Technical Service Bulletin: TSB110189

New Turbocharger Oil Supply Line Male Union, QSK19 Engine

Figure 1. Old Male Union Versus New Taller Male Union

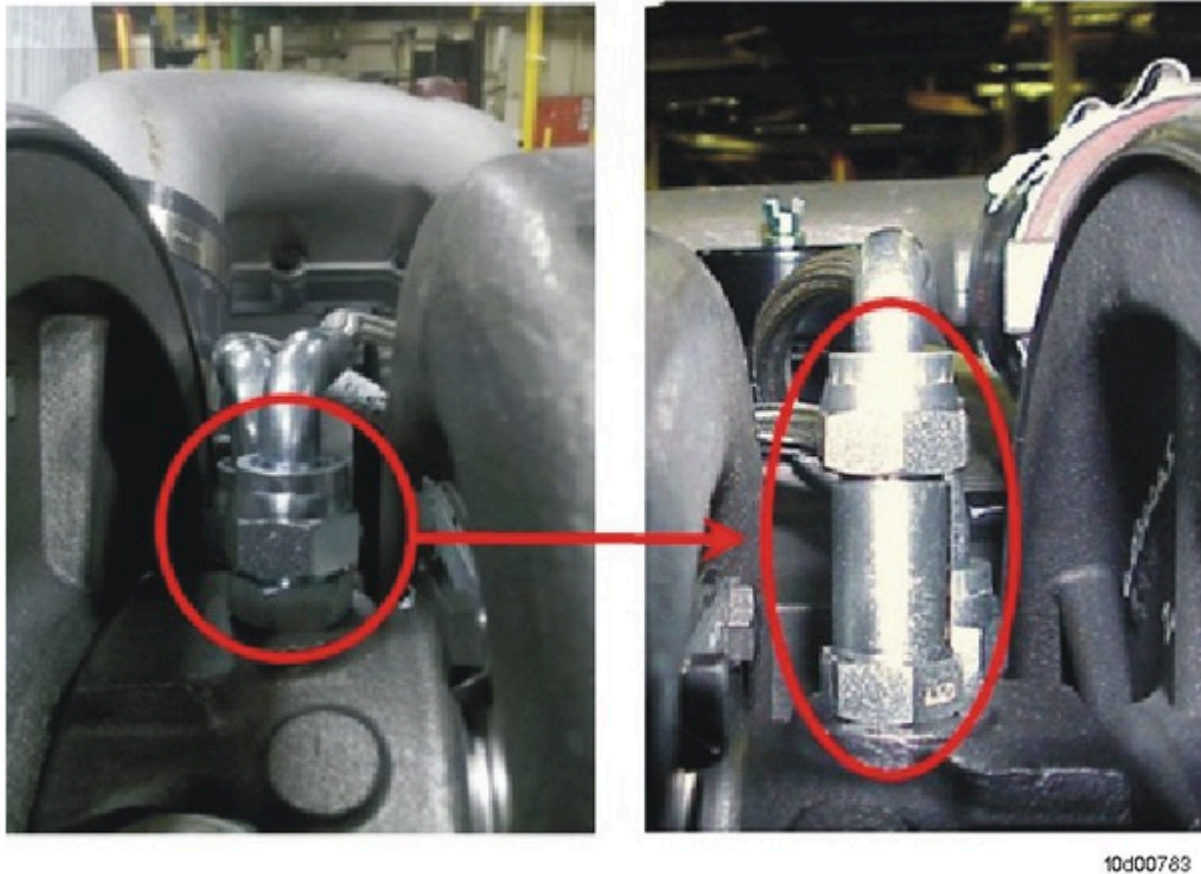
The new male union is taller than the previous unions used at the turbocharger oil inlet. This allows for more clearance between the turbocharger oil supply hose and other objects in this area, including the bearing housing and coolant vent line. Figure 1 shows the old fitting on the left and the new fitting on the right.

Figure 2. Previous Speed Sensor Wire Routing with Bracket

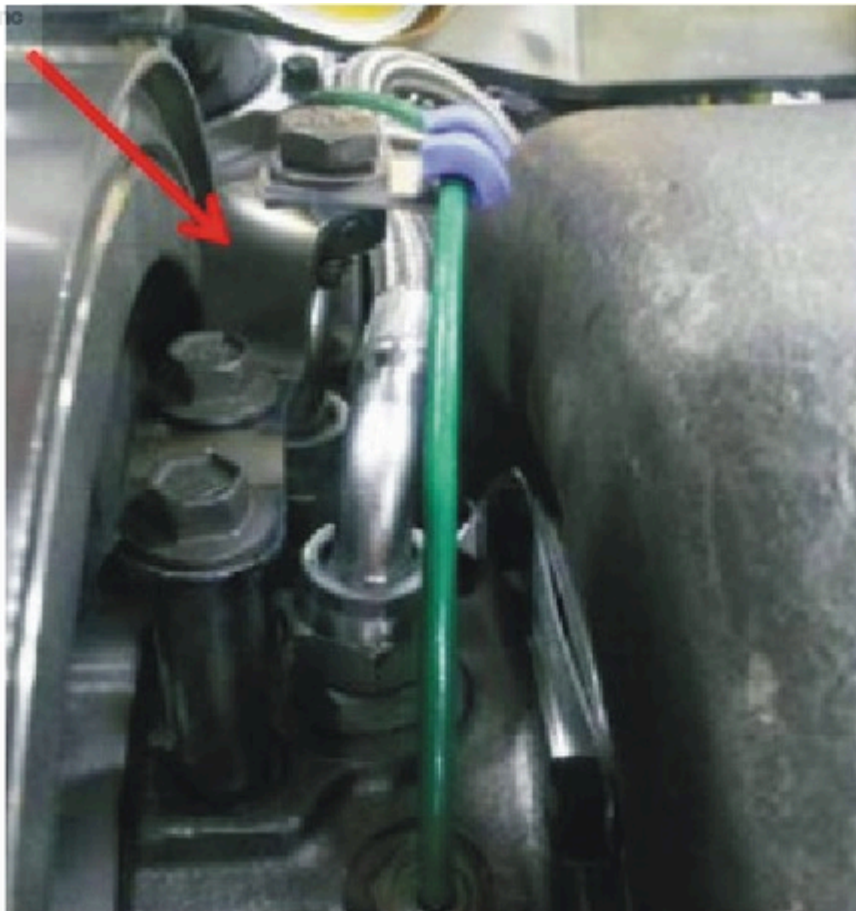
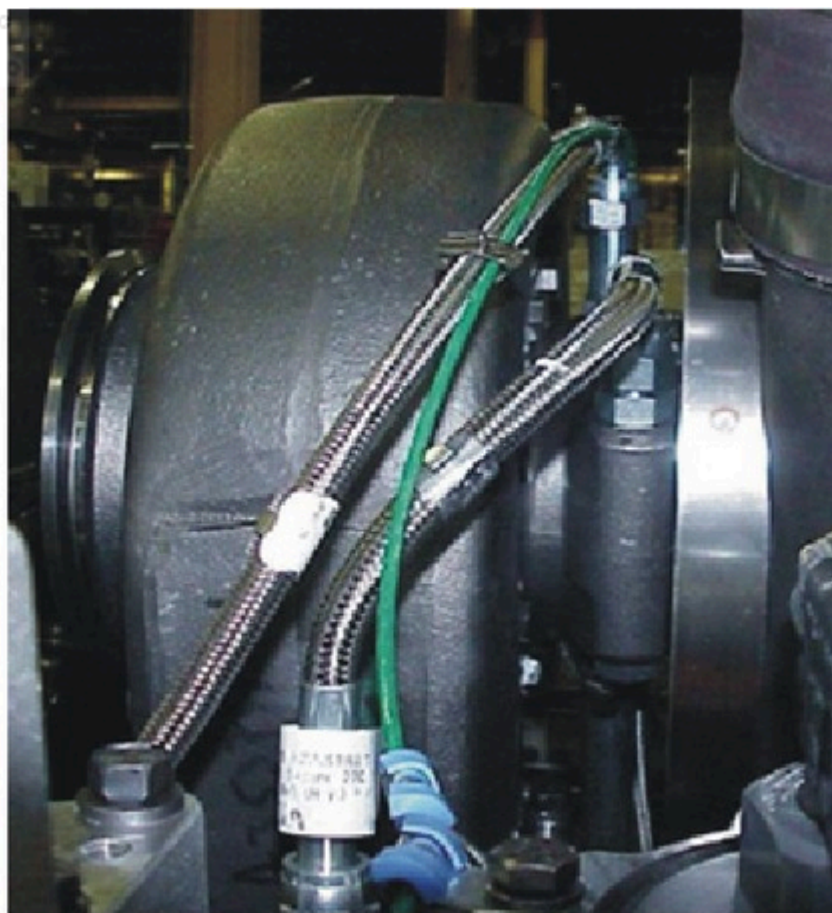
On QSK19 MCRS Tier 3 options with a turbocharger speed sensor, this new male union causes an interference with the bracket supporting the speed sensor wire. To resolve this, the bracket has been obsoleted and the hardware has been removed from the affected options. Now, the wire should be clipped to the oil supply line to allow for maximum clearance. This is similar routing to other turbocharger options. Table 3 shows the structure changes to these options. Figure 2 shows the bracket that is being obsoleted. Figure 3 shows the new turbocharger speed sensor wire routing. Table 4 shows the options that had the bracket removed.

Procedures 13-019-390 in the QSK19 (CM850 Modular Common Rail System) Electronic Control System Troubleshooting and Repair Manual, Bulletin 4021493, and procedure 123-019-390 in the QSK19 CM2150 Electronic Control System Troubleshooting and Repair Manual, Bulletin 4022094, have been updated to include removal of the bracket and installation of the clips to attach the speed sensor wire to the oil supply line.
